City of Mississauga Department Comments

Date Finalized: 2023-04-05 File(s): A63.23

The applicant is proposing a second unit requiring a variance for an interior side yard setback to a below grade entrance.

Minor Variance Application: A-63/23 – 3463 Mulcaster Road

Appendix 1 – Transportation and Works Comments

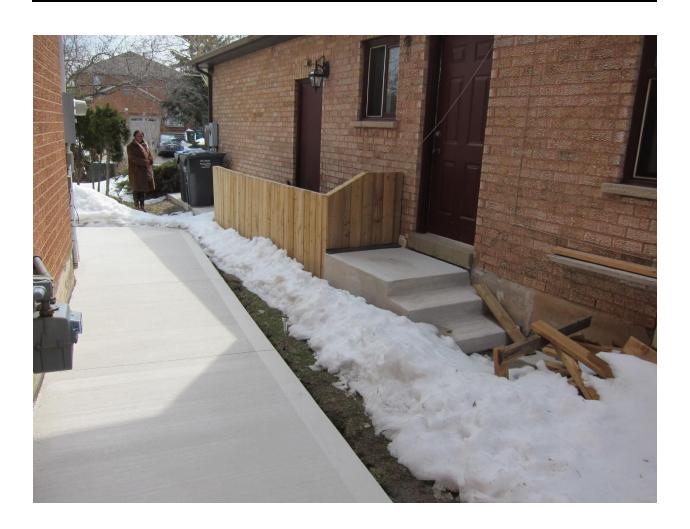
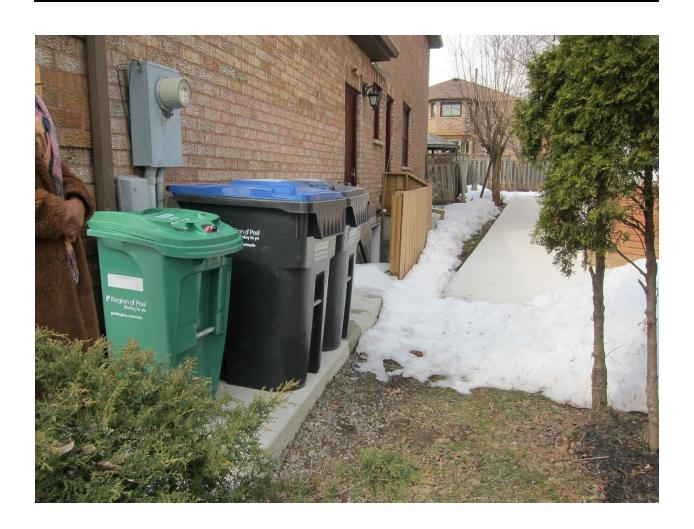
Enclosed for Committee's easy reference are photos of the side yard where the basement entrance is proposed, as well as the opposite side yard of the dwelling. We do not have any drainage concerns.
